**SAN ANTONIO WATER SYSTEM
CENTRAL WATER INTEGRATION PIPELINE
MALTSBERGER PUMP STATION IMPROVEMENTS
SAWS Job No. 18-8617
SAWS Solicitation No. CO-00190**

**ADDENDUM No. 4
August 31, 2018**

**INTERCONNECTION
PLAN & PROFILE PRV2**

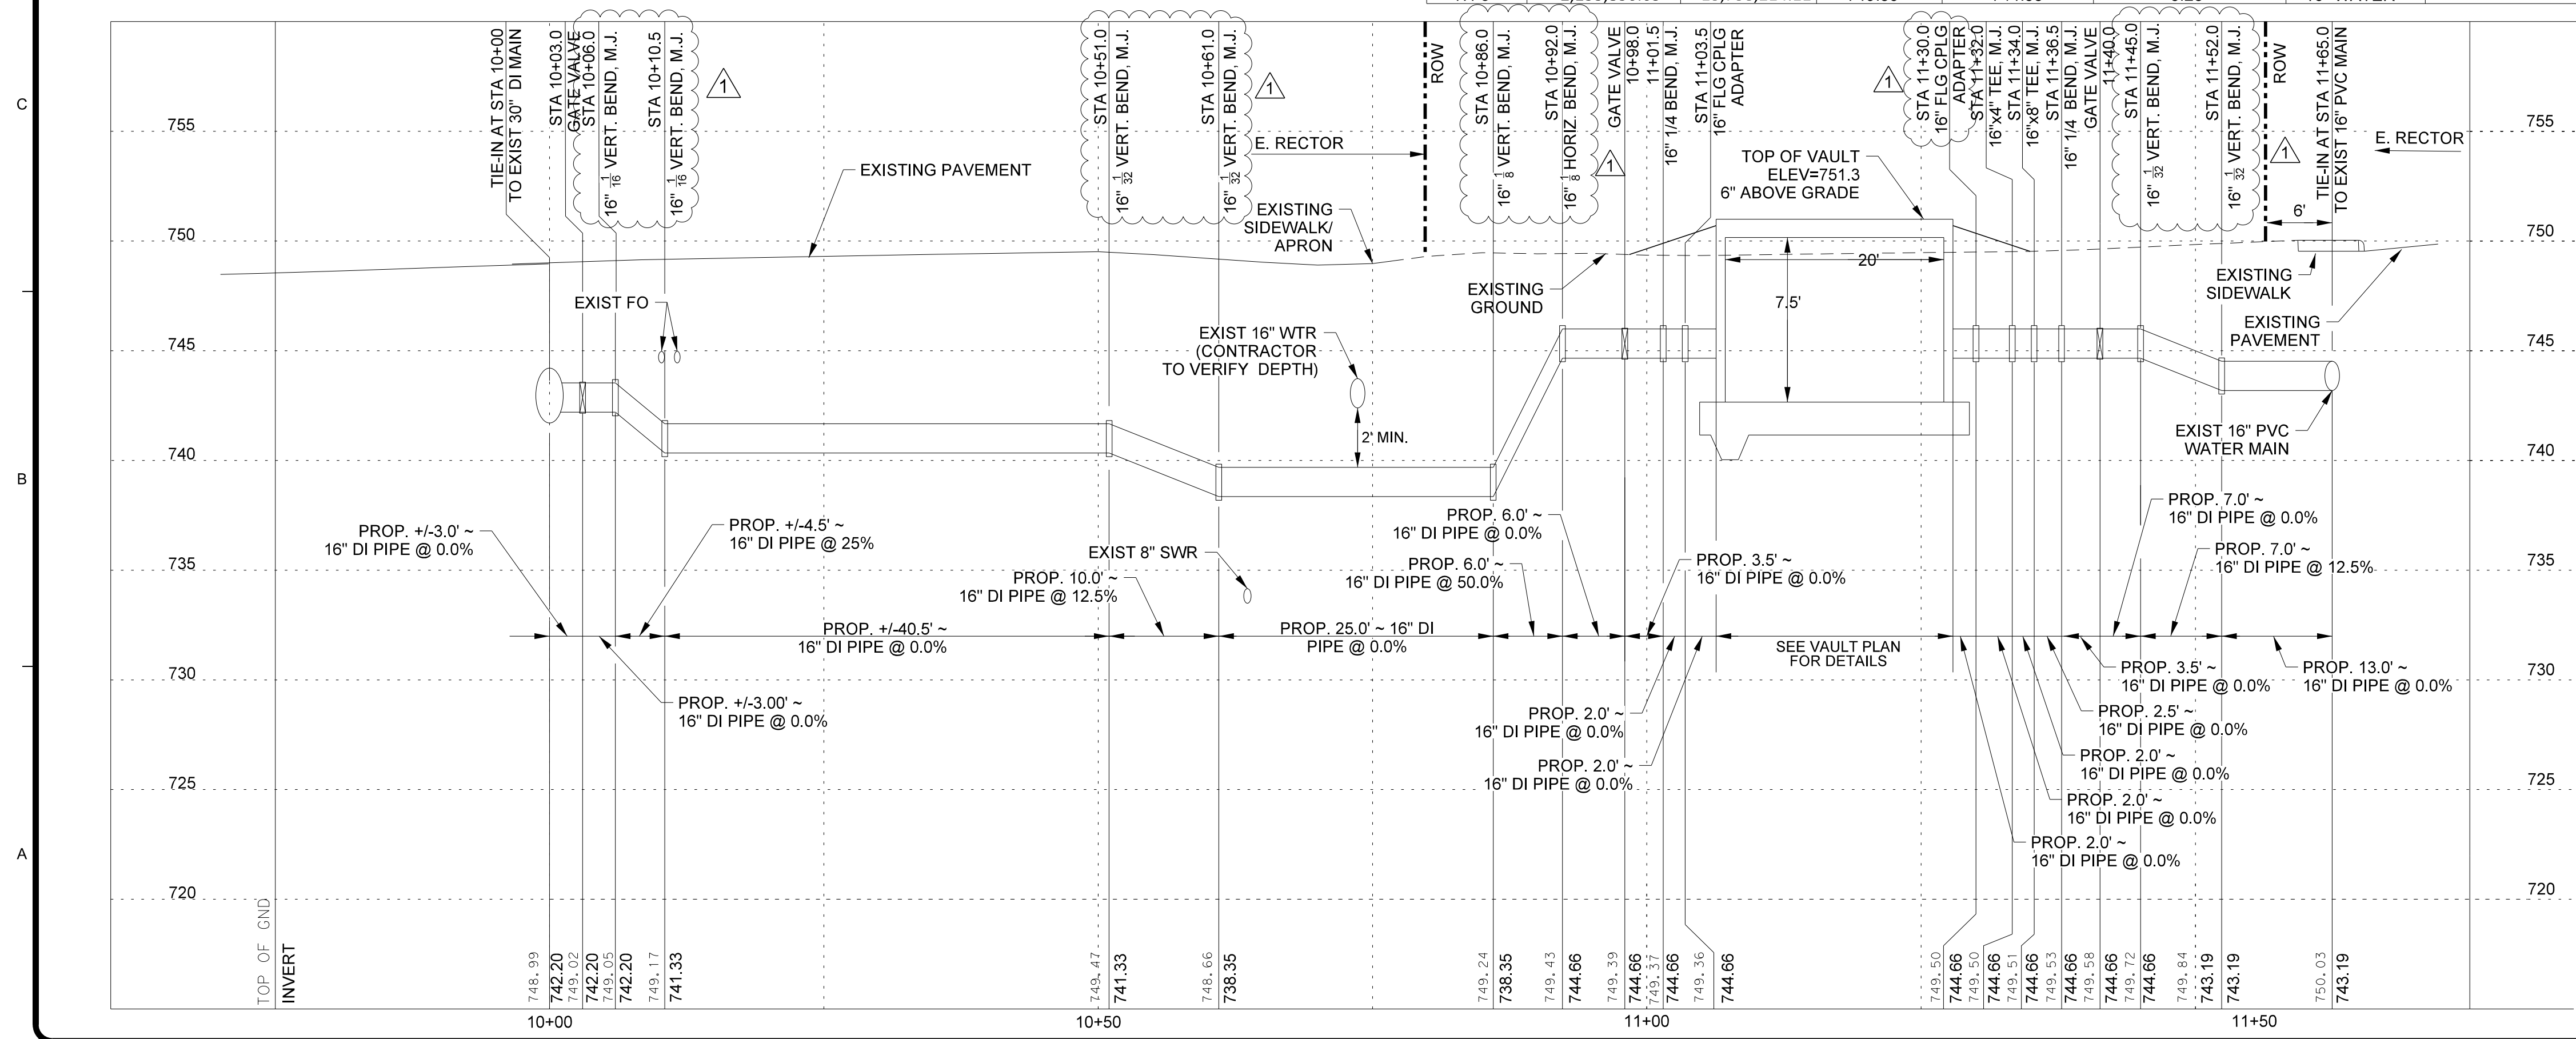
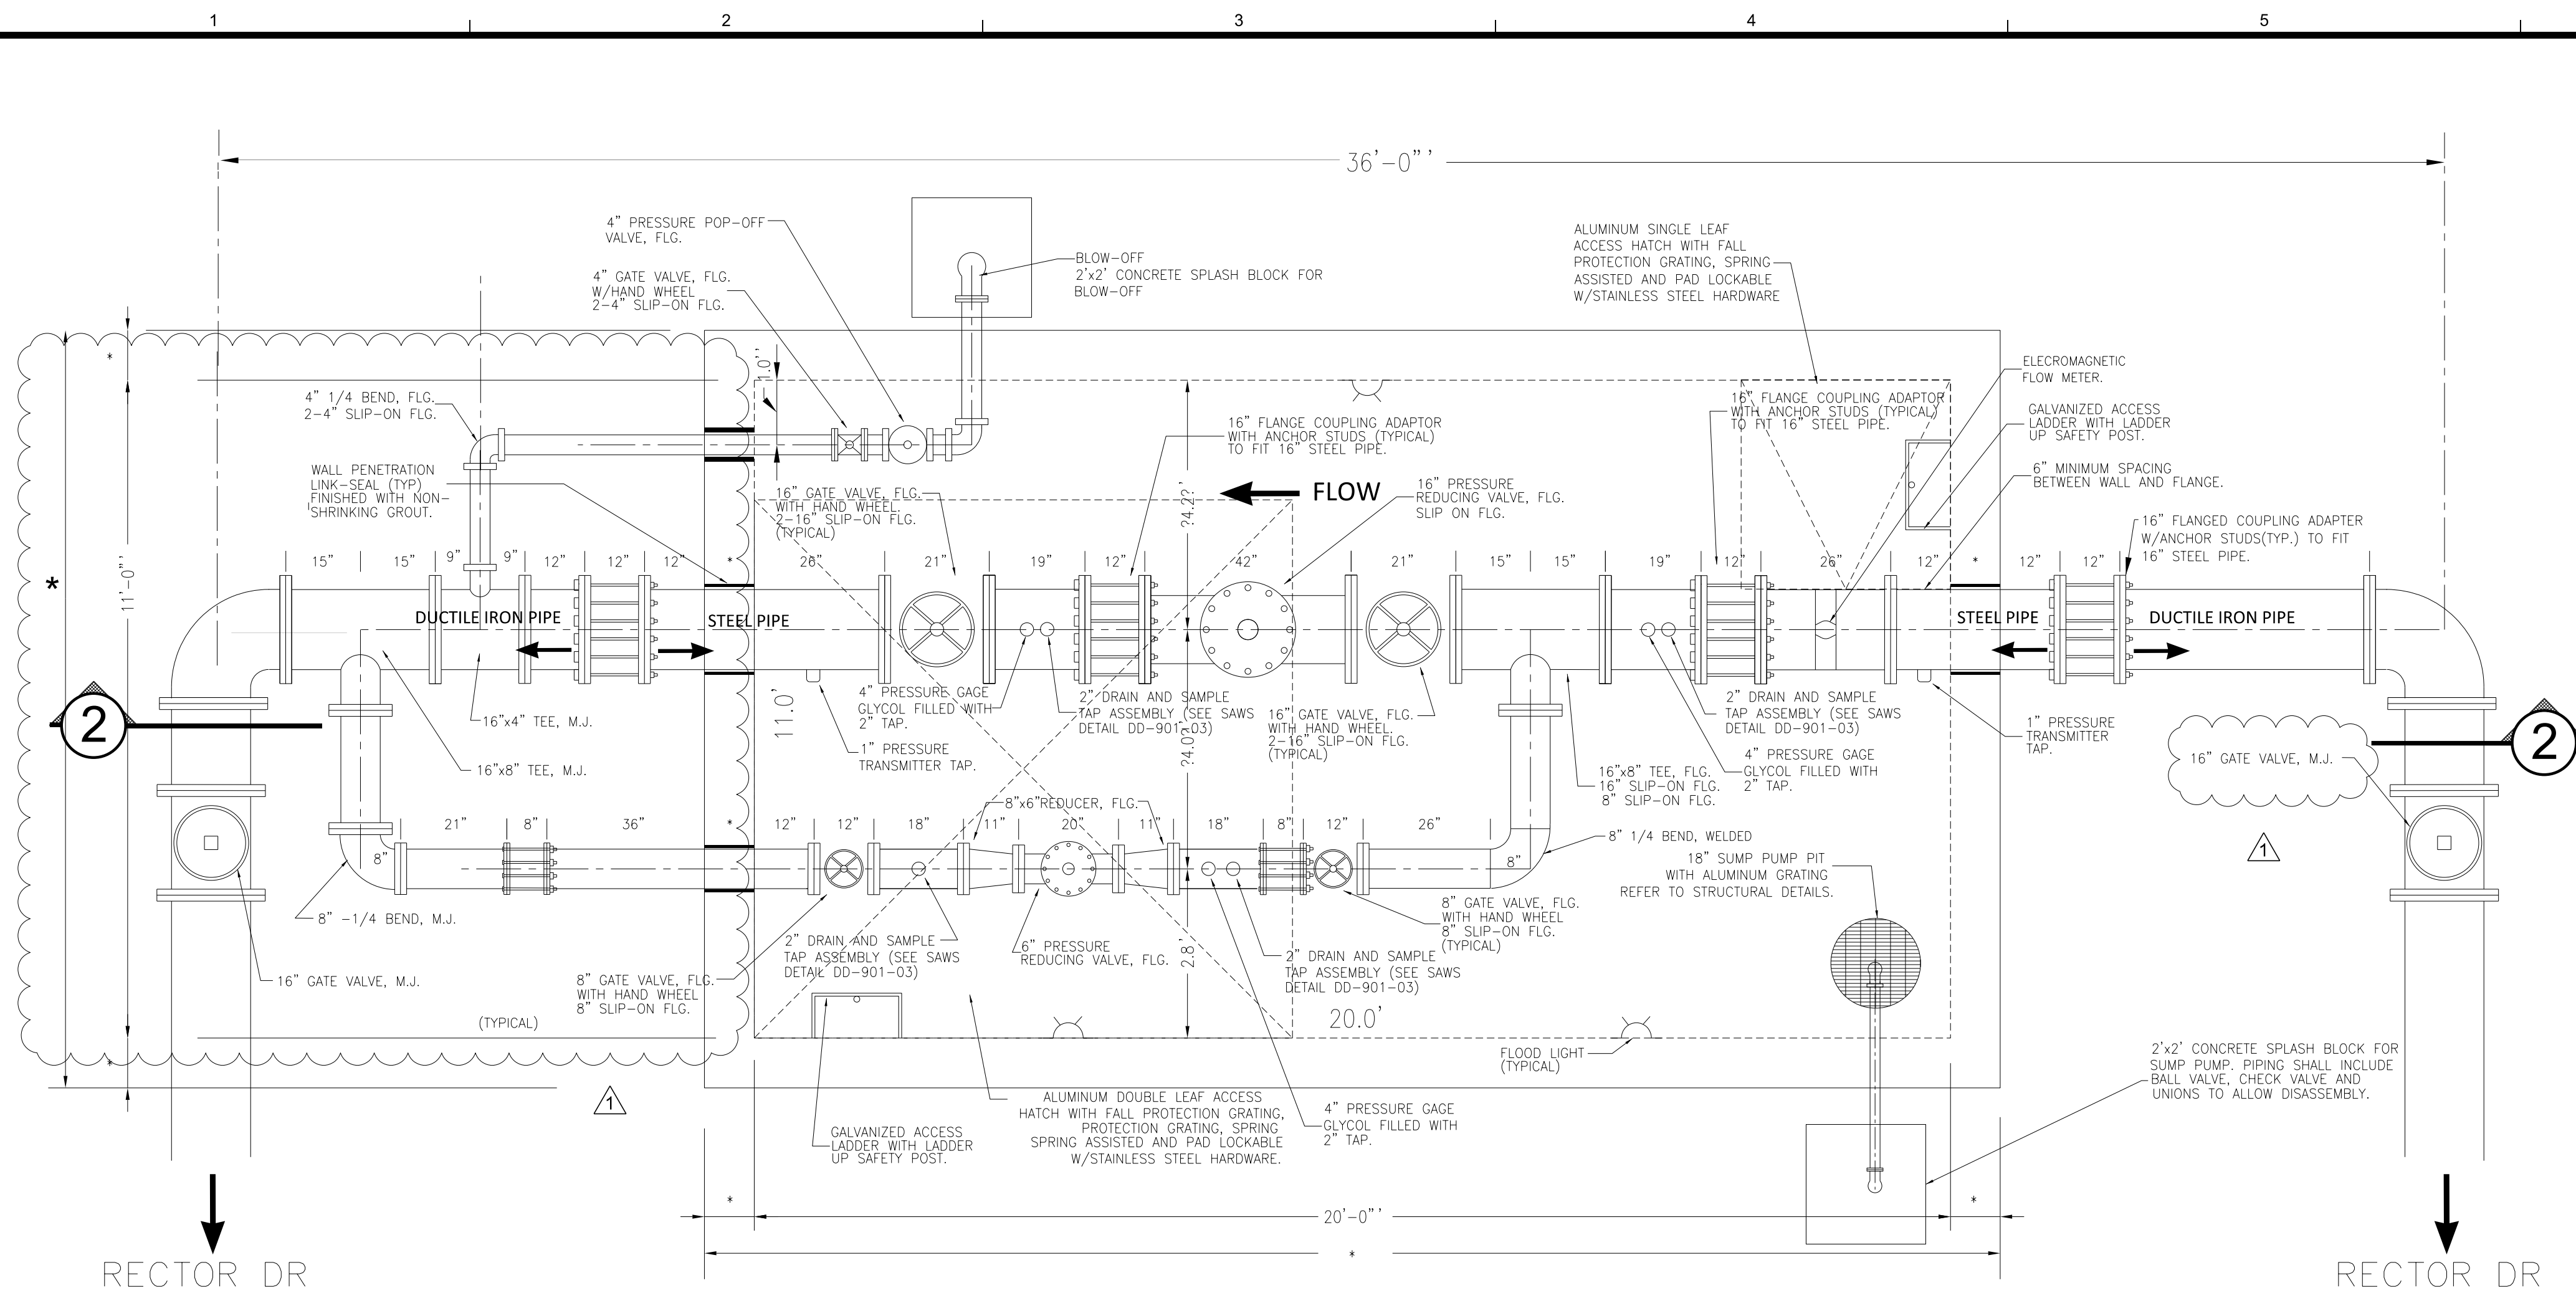
90	Please provide a light fixture schedule for the fixtures shown to be installed in the electrical building at the Maltberger Pump Station	Luminaire schedule has been provided. This is reflected in the changes to SHEET E-2338 per Addendum No. 4.
91	Sheet M-2302; "This is not a 45 deg bend (1/8)"	Refer to updated SHEET M-2302 per Addendum No. 4.

Question No.	Question	Answer
92	Sheet M-2302; "This is not a 90 deg bend (1/4)"	Refer to updated SHEET M-2302 per Addendum No. 4.
93	Sheet M-2304; "Can't put a slip on flange on a gate valve or on DI Pipe".	Refer to updated SHEET M-2304 per Addendum No. 4.
94	Sheet M-2304; "M-2302 shows these to be MJ. Can't be steel and MJ. Where do you want to change from DI to Steel?"	Refer to updated SHEET M-2304 per Addendum No. 4.
95	Sheet M-2306; "These are not 1/4 bends. They are about 30-35 deg. Closest available MJ fitting is 22.5 deg."	Refer to updated SHEET M-2306 per Addendum No. 4.
96	Sheet M-2306; "These are not 1/4 bends. They are about 60 deg. 60 deg MJ fittings are not available."	Refer to updated SHEET M-2306 per Addendum No. 4.
101	On drawing E-2343 are we to supply equipment on this drawing? If so can we can more detail on the lines sizes and etc..	Refer to updated SHEET E-2343 per Addendum No. 4.
